## OFFICE PLANS

## EXERCISE ROOM PARTIAL PLAN

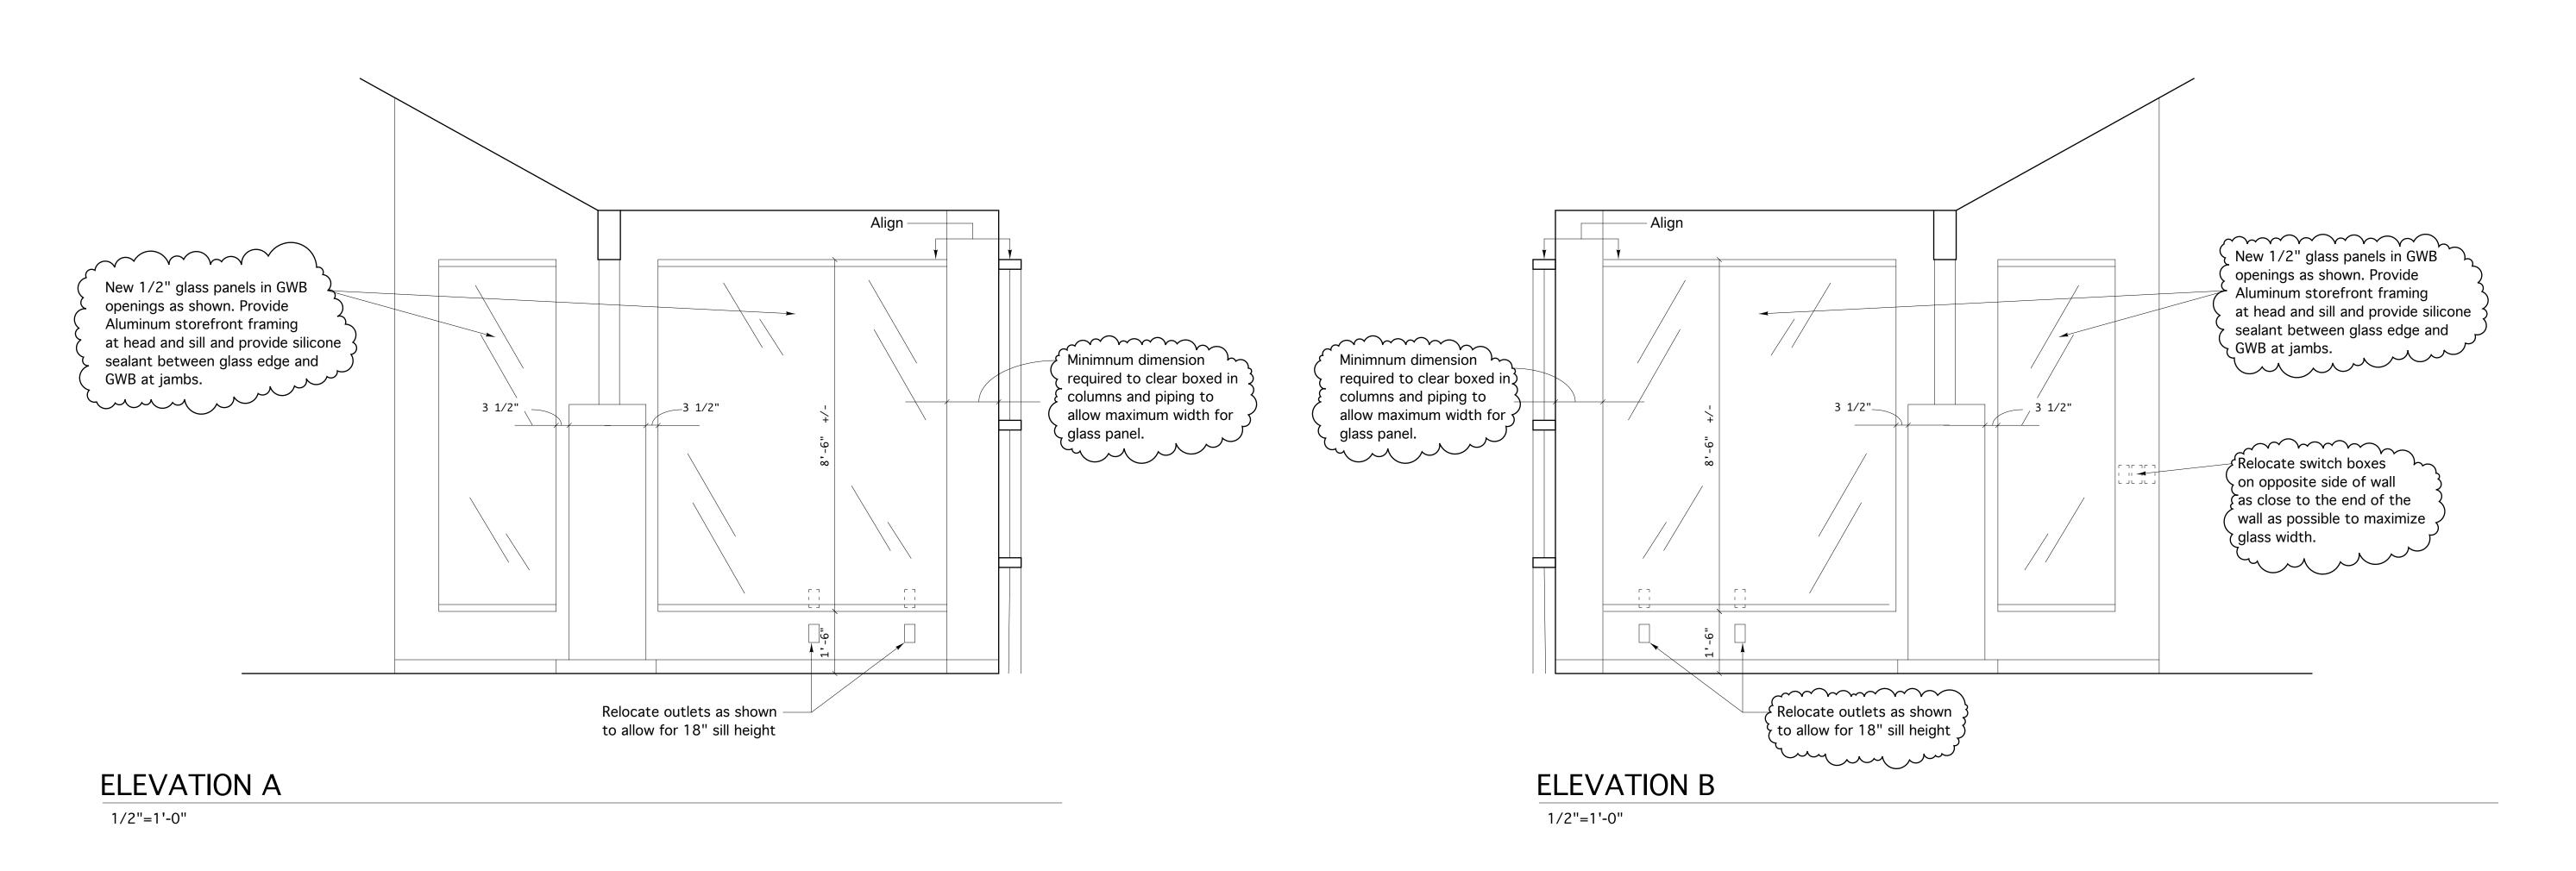
## Add two new aluminum framed glass panels as shown. Openings to match head and sill heights of adjacent glass panels and be as wide as possible while clearing the diagonal wood timber coming through the wall between them. The water curtain sprinkler system shall be extended around the corner with a sprinkler system shall be extended around the corner with a sprinkler system shall be active and the corner with a sprinkler system shall be active and the corner with a sprinkler system shall be active as a detailed in ASK 35.
